AIRWORTHINESS DIRECTIVE

Schempp-Hirth Cirrus
Cirrus VTC

Inspection of the divebrake control system.

GFA AD 317	Issue 1
3/9/1987	Sheet 2 of 3

FIGURE 1.

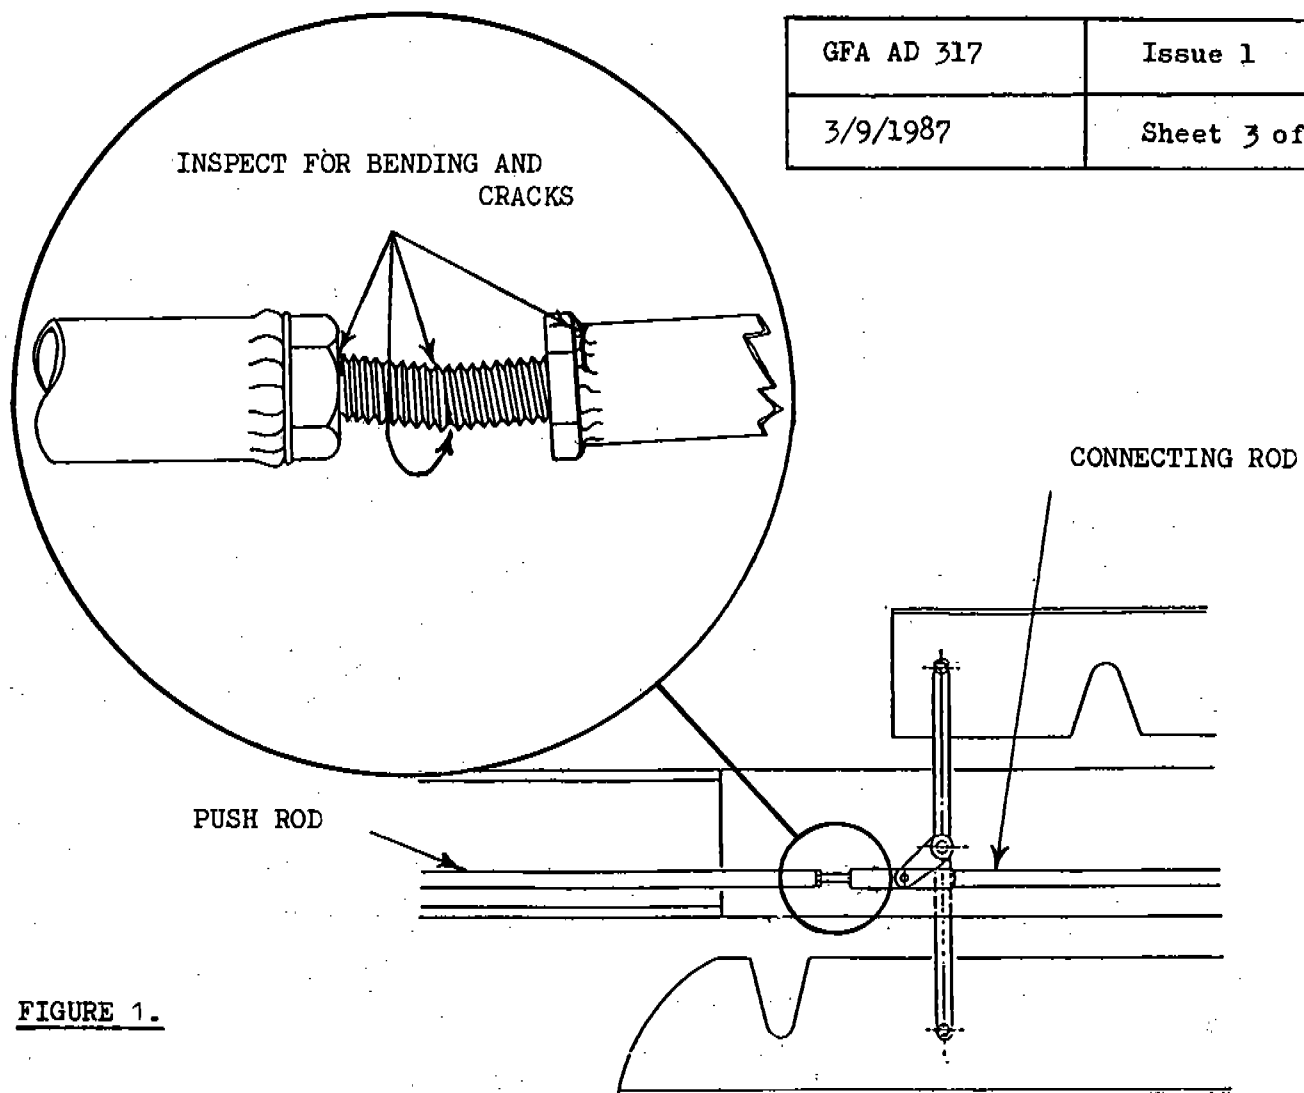
On several Cirrus sailplanes overseas the bolt welded to the connecting rod for the divebrake arms (Fig. 1) has given trouble. (Schempp-Hirth Technical Note 265.8).

FIGURE 2.

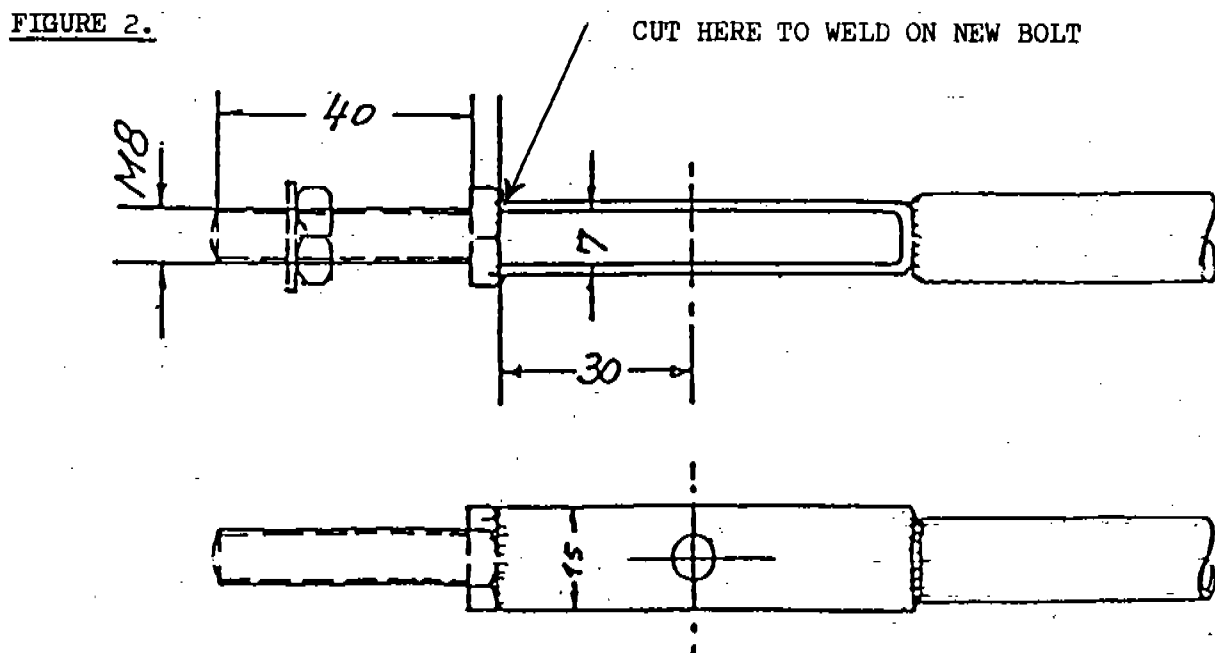
1. Remove the divebrake arm connecting rods from both wings and inspect them for defects.
 - (a) If the bolt is bent or cracked the connecting rod must be replaced with a new one or be repaired by cutting off the old bolt at the weld and welding on a new 8mm bolt. (Fig. 2).
 - (b) If the weld only is cracked and the bolt shows no other defects it may be repaired by re-welding.
 - (c) If the connecting rod has a 6mm bolt (Serials Nos 1 to 50 and it shows any of the above defects it must be replaced with a new connecting rod or the bolt cut off and new 8mm bolt welded on. The push rod will need to be drilled and tapped to suit.

NOTE: A BENT BOLT MUST NOT BE STRAIGHTENED.
